P 516458
A REPAIR

ON-SITE SEWAGE DISPOSAL SYSTEM HOWARD COUNTY HEALTH DEPARTMENT BUREAU OF ENVIRONMENTAL HEALTH

ADDRESS: 15601 Bushy Park Road PROPERTY OWNER: Thomas & Claudia Allnut

SITE PLAN.
 15601 BUSH PARK RD. HOWARD COUNTY MD.
 THOMAS R. AND CLAUDIA T. ALLNUTT
 LIBER 1754 - FOLIO 217
 ELECTION DISTRICT No. 4

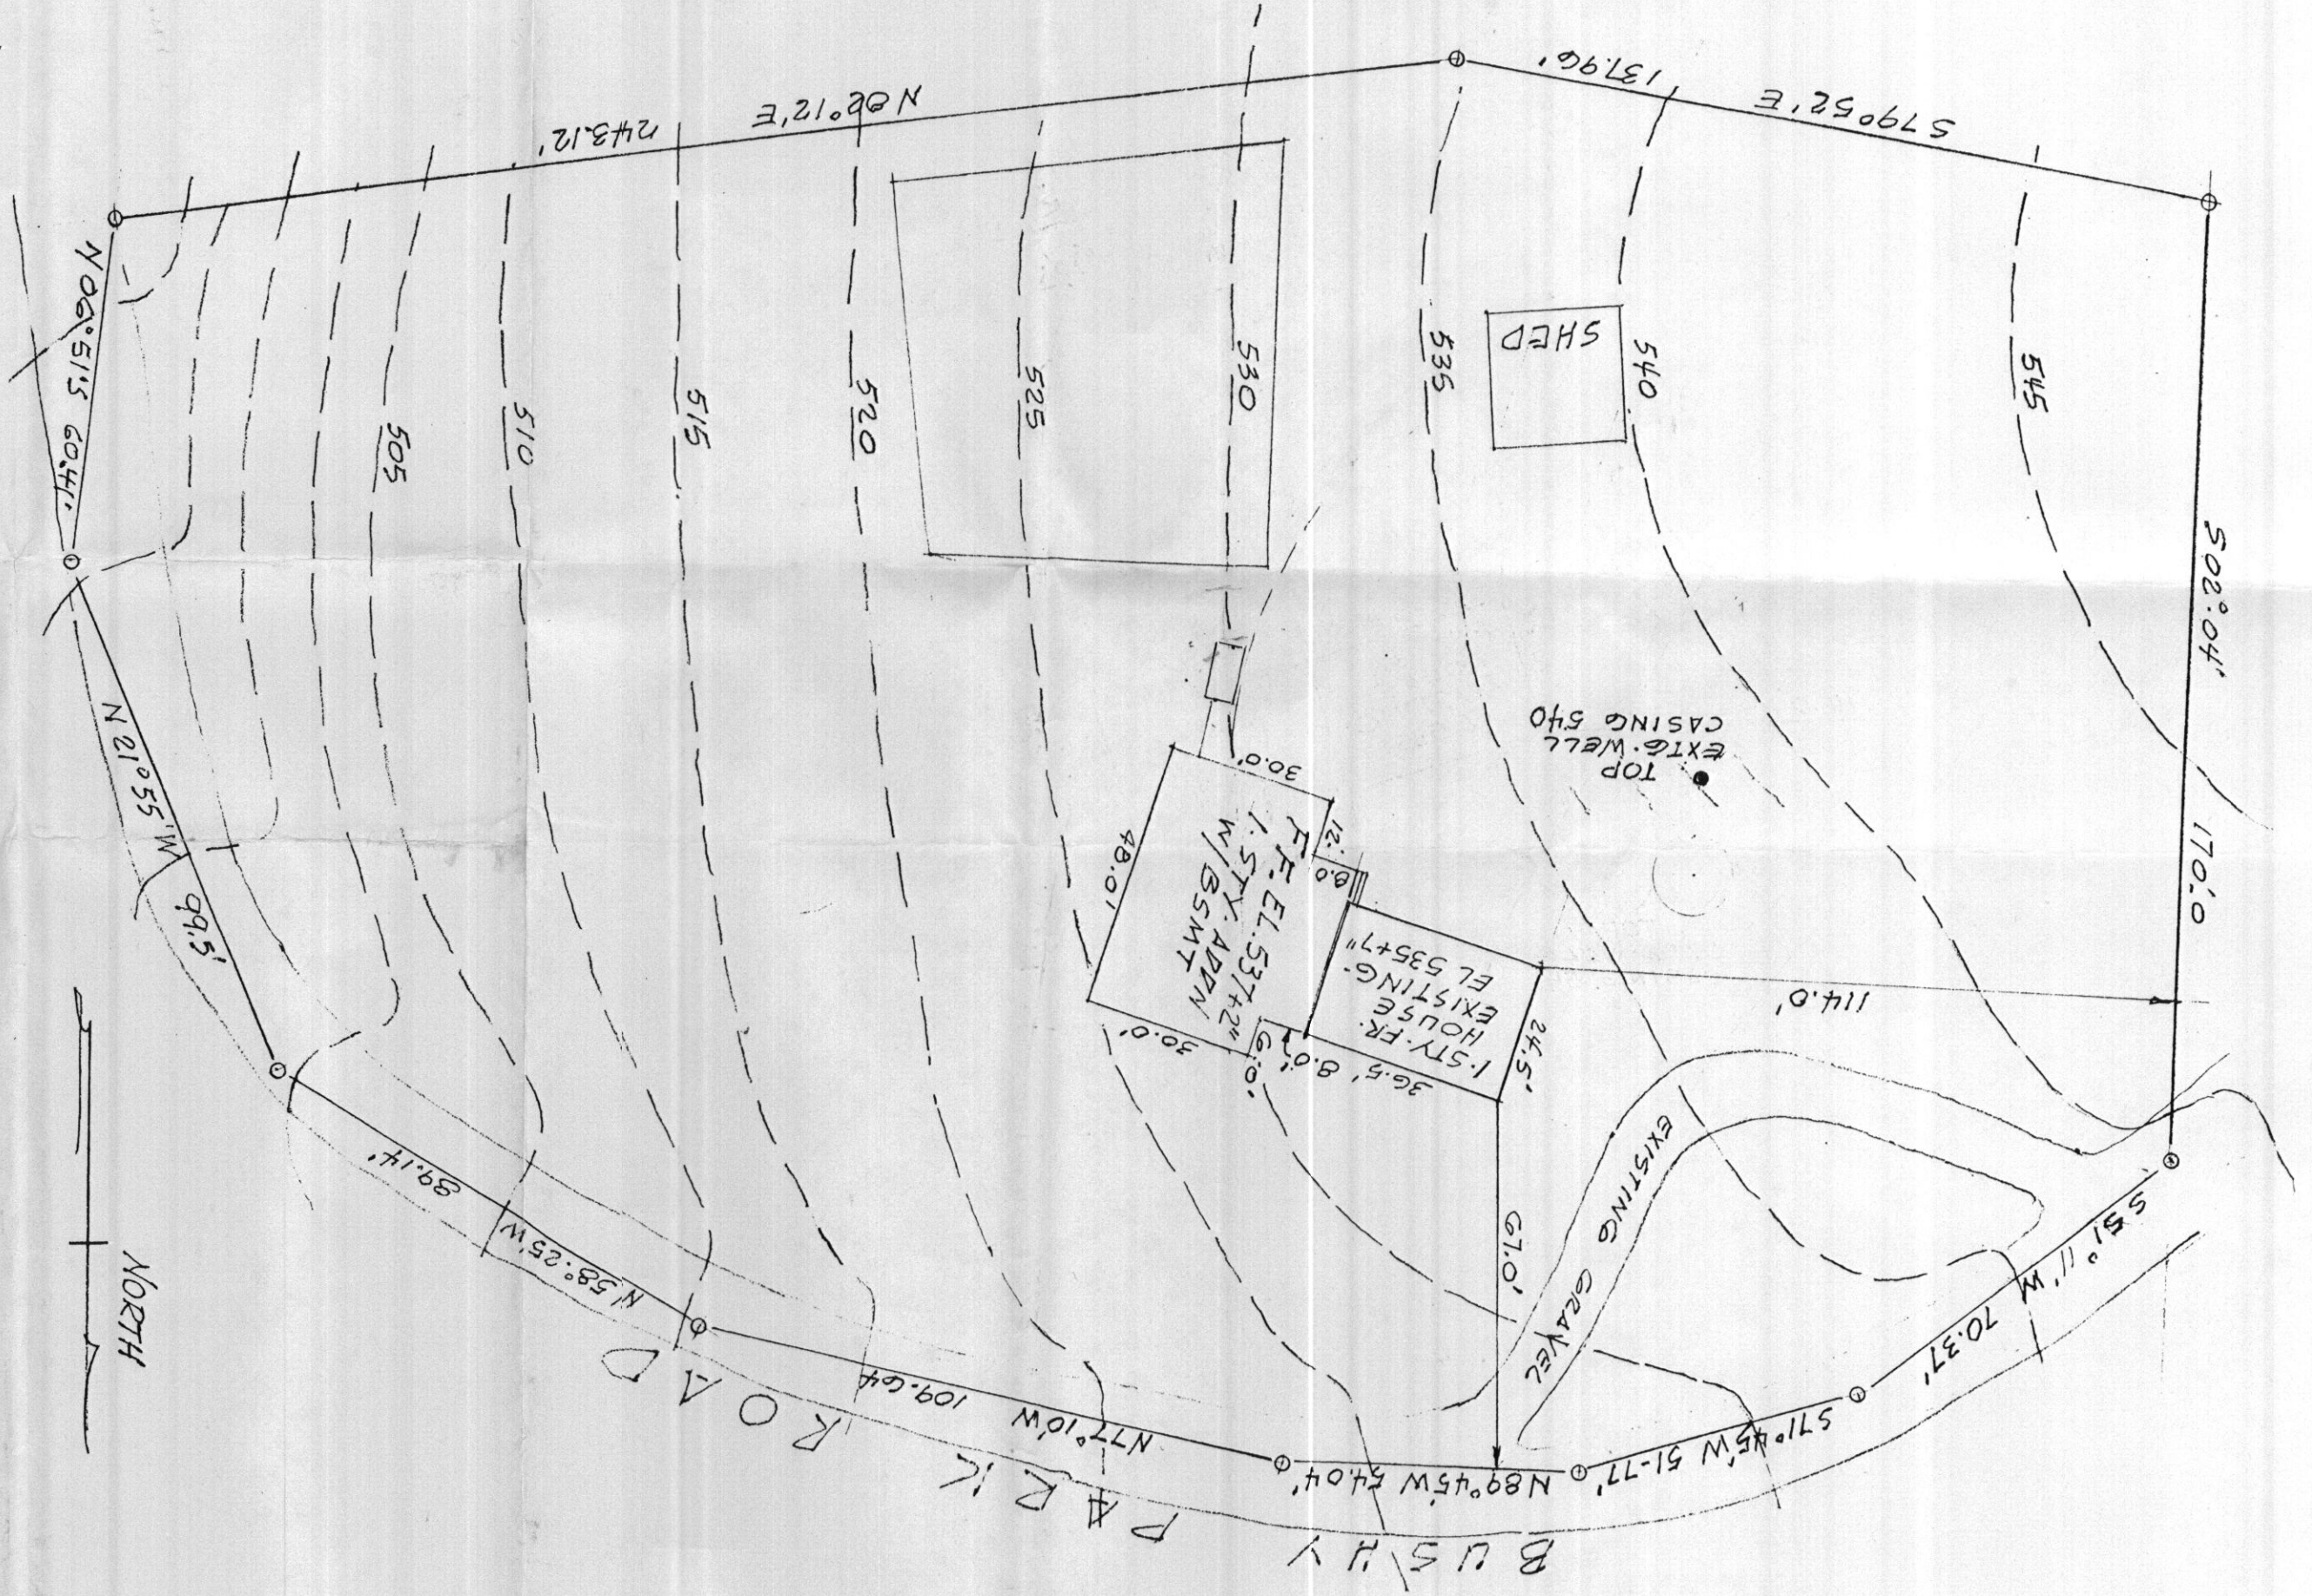
INSTALLATION 4/9/02 Trenches are slightly off contour and deeper in centers. Top trench 3' deep in center. Will accept as is since septic tank is 18"-3' above grade in order to get trenches as shallow as they are. O.K. to cover. Need connection to new addition. (BB) Final inspection never called in. Will accept as is. 12/24/03 (BB)
